Addendum No. 2

1/30/25

College of Southern Idaho Leroy Craig Center

**PROJECT: LeRoy Craig Jerome Center
College of Southern Idaho
Jerome, Idaho**

SK-2

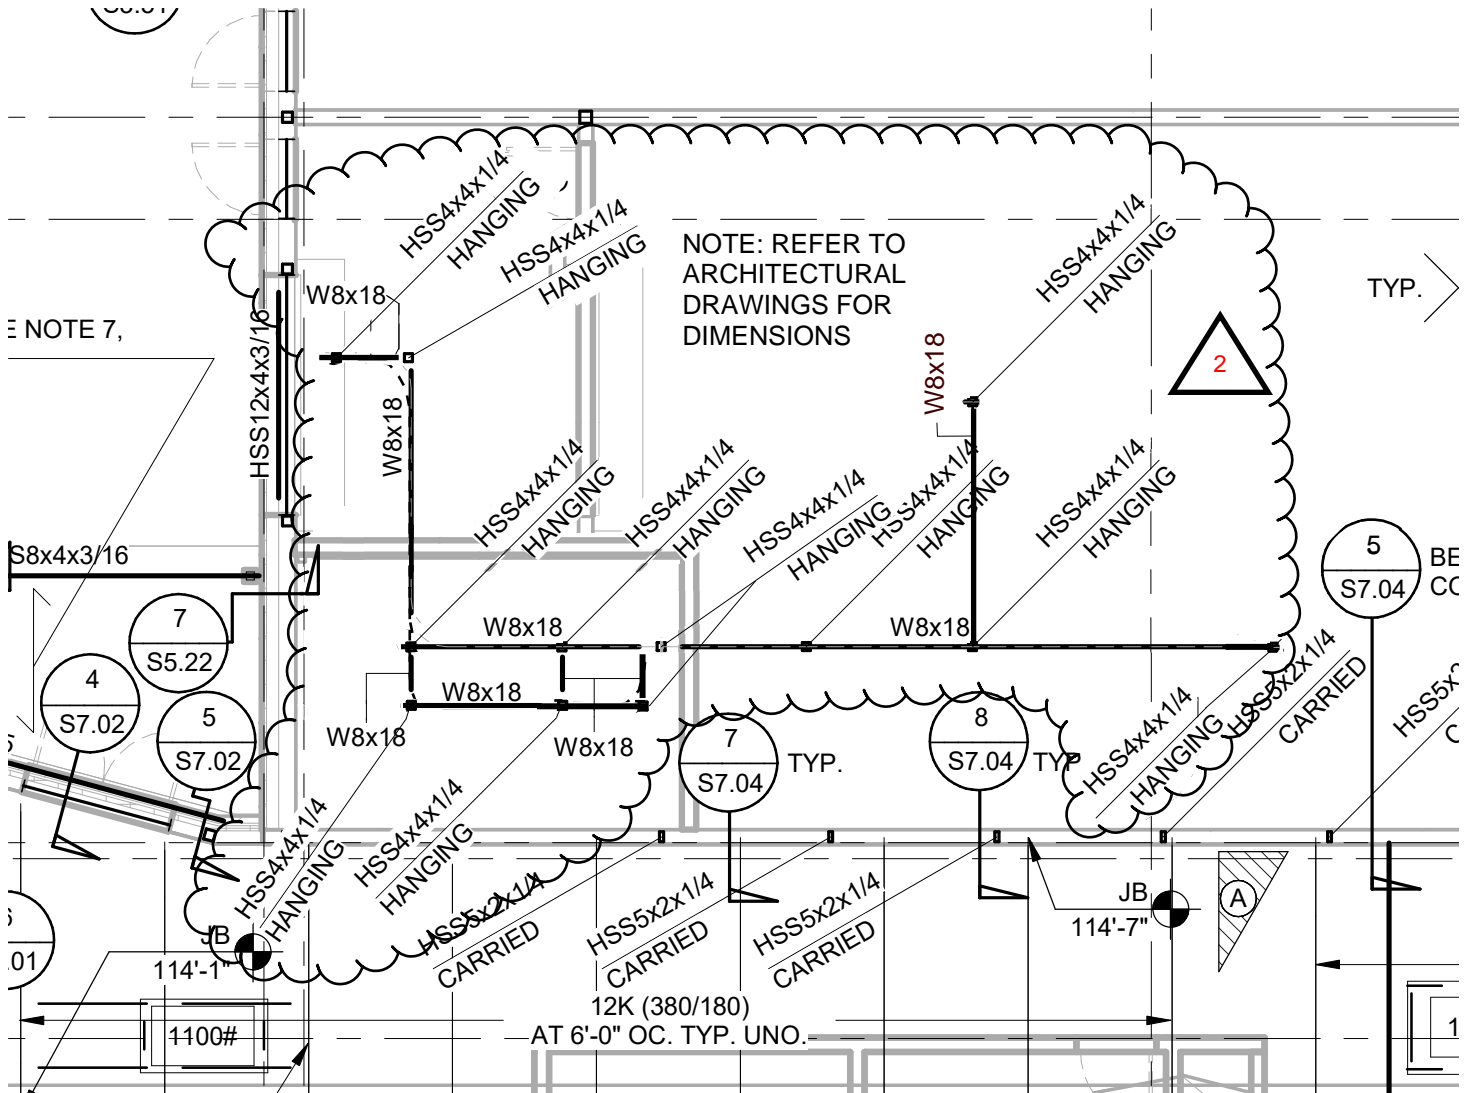
1. See attached Sketch SK-2 for clarifications to the meat rail layout dimensions in TRAINING LAB 2 and accordingly, attached Sketches LESK 01 and LESK 02 for adjustments to supporting structural steel. (re: Sheets S1.02 & S1.03)

SHOWING MEAT RAIL DIMENSIONS

NOTE: MEAT RAIL BY OWNER. SEE FOODSERVICE DOCUMENTS. SEE STRUCTURAL SKETCHES LESK 01 AND LESK 02 FOR STRUCTURAL STEEL SUPPORT.

DRAWN BY: CI
CHECKED BY: JB
BID SET
DRAWING NO.
SD3.0
LAYOUT PLAN

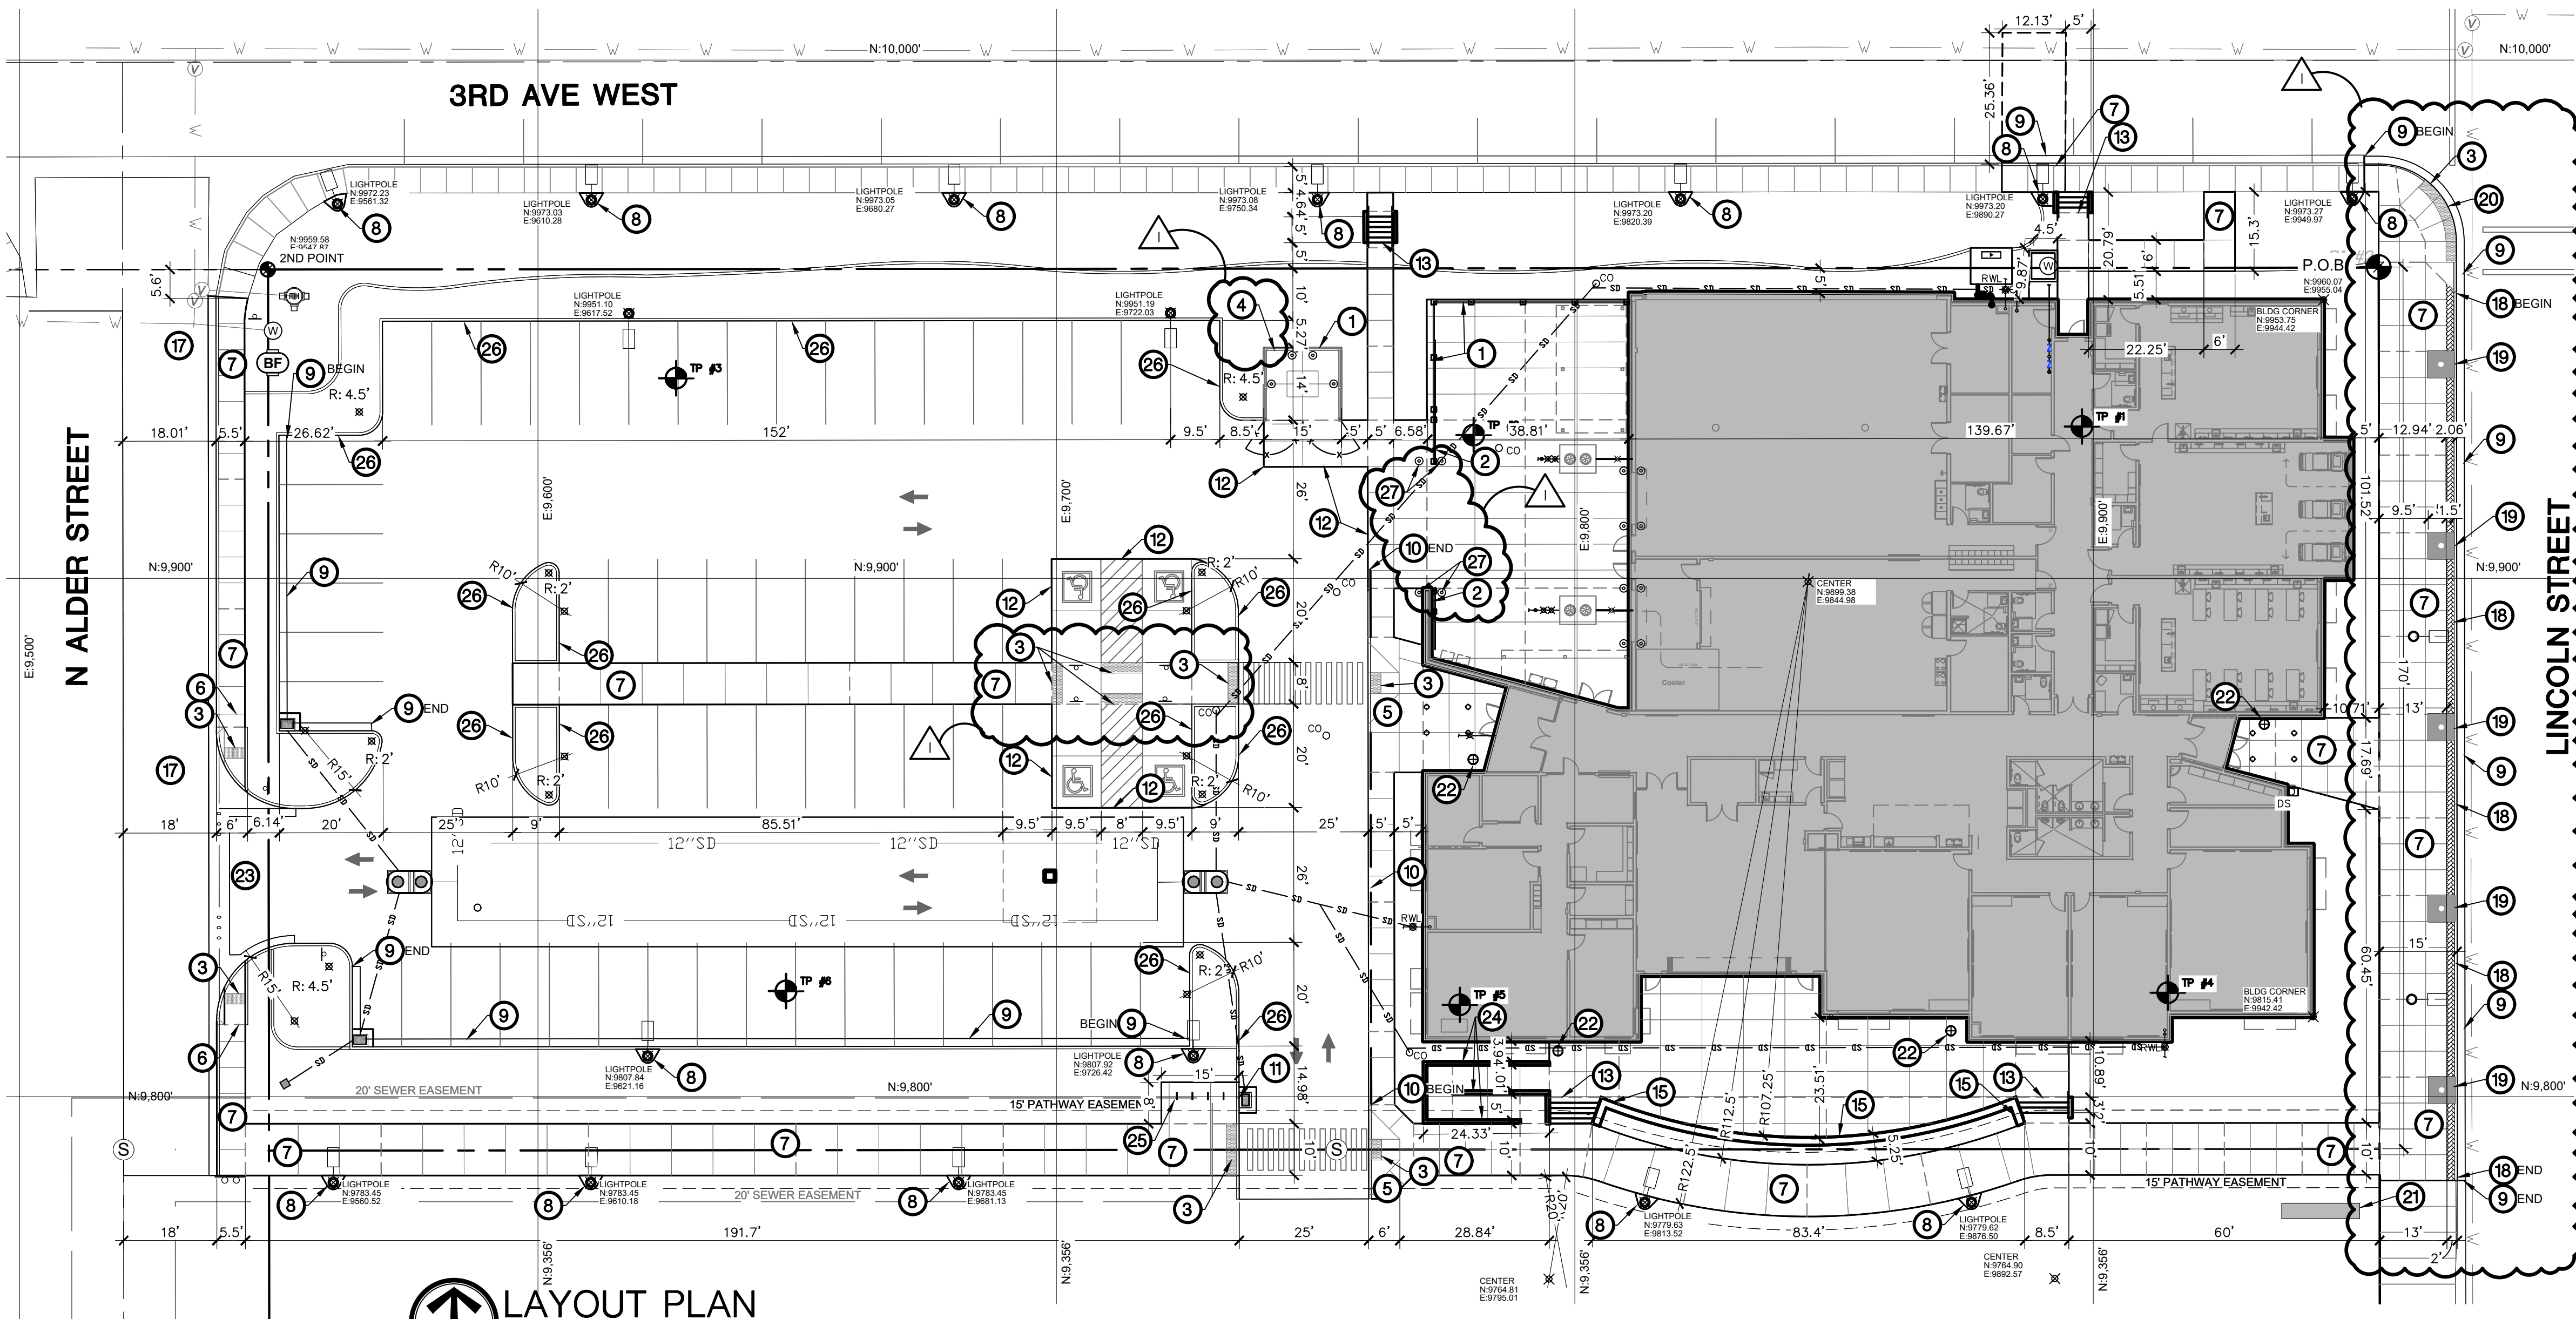
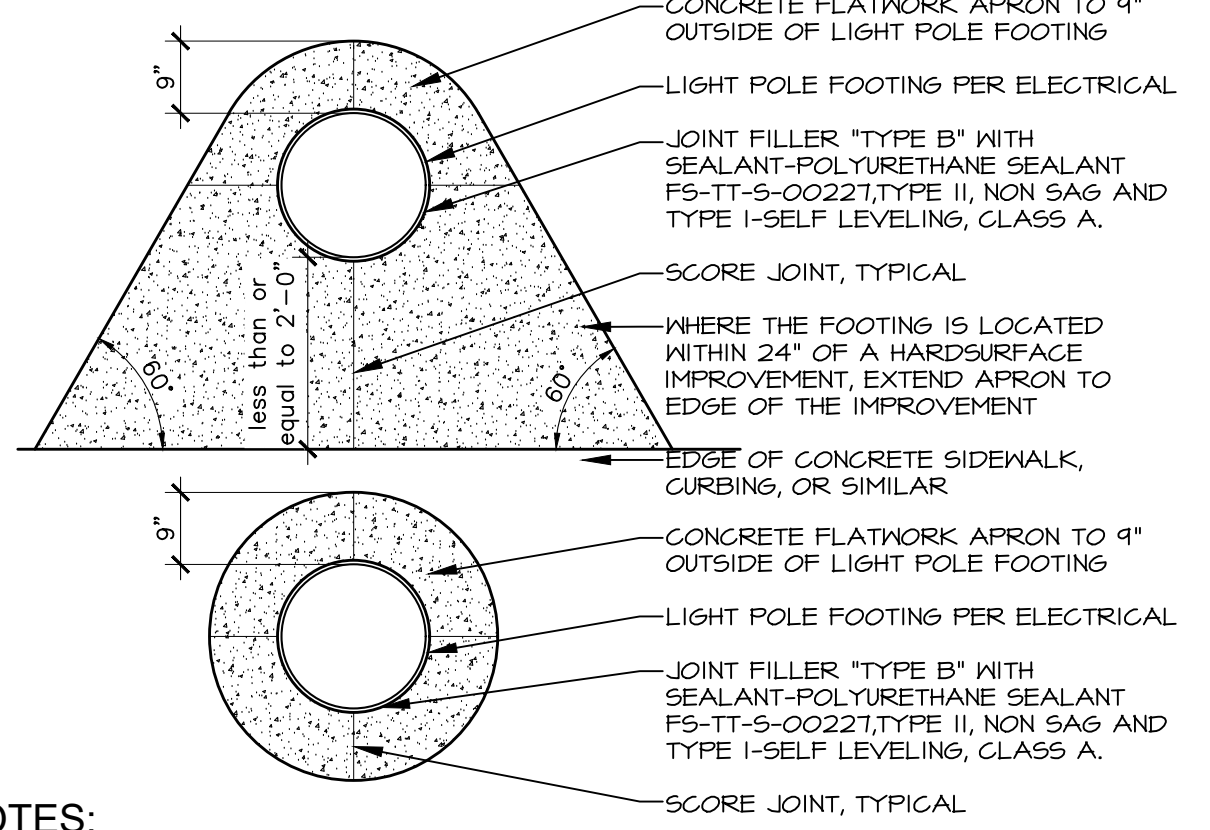
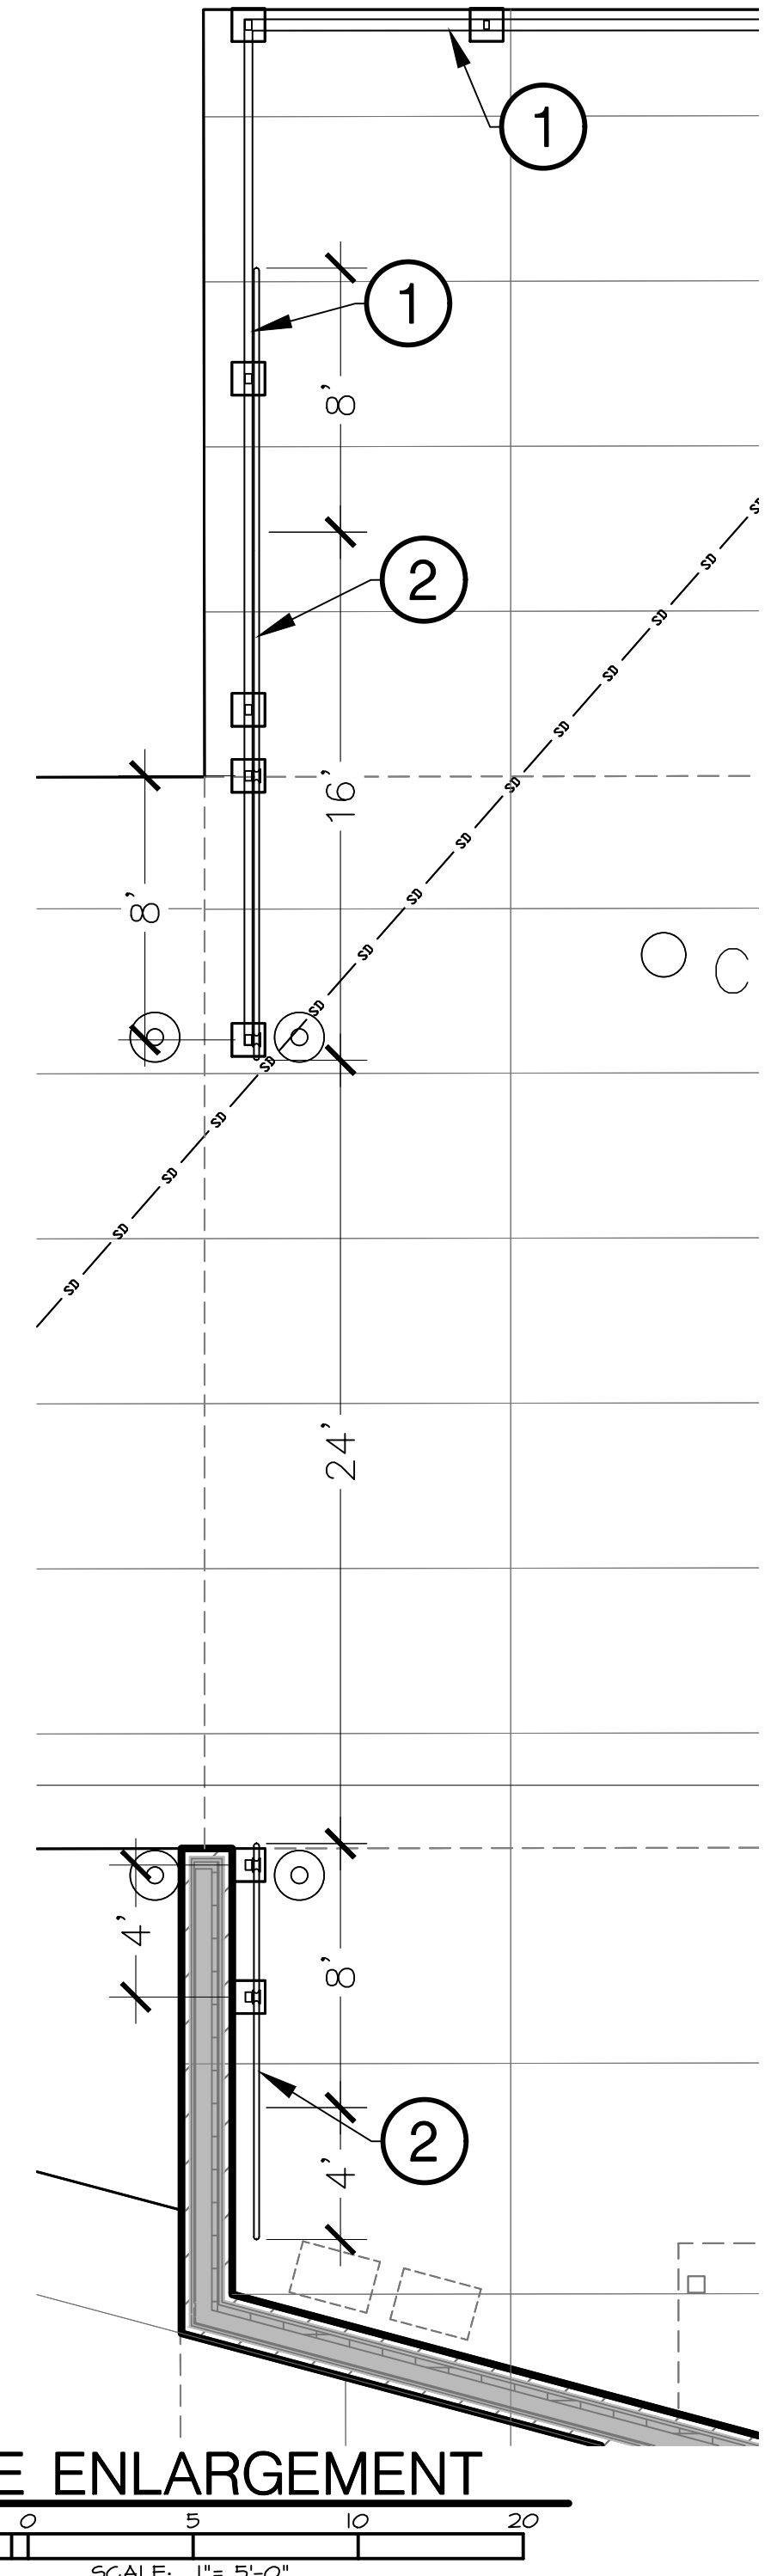
- 1-3 Sheet SD3.0, Callout 4 replaced with "Trash enclosure, see enlargement on sheet SD3.7"
- 1-4 Sheet SD3.0, Add 24 linear feet of detectable warning locations near the ADA parking stalls.

- 1-5 Sheet SD3.0, Revise ADA ramp style on the corner of Lincoln and 3rd Ave.
- 1-6 Sheet SD3.0, Revise tree grate locations along Lincoln Street
- 1-7 Sheet SD3.0, Revise callout 19 to specify the tree gate to be used.

- 1-8 Sheet SD3.0, Add callout 27, Steel Bollard locations.
- 1-9 Sheet SD3.5, Delete detail 9.
- 1-10 Sheet SD7.0, Replace sheet, per attached.
- 1-11 Sheet SD7.0 Replace callout 12 with "not used".
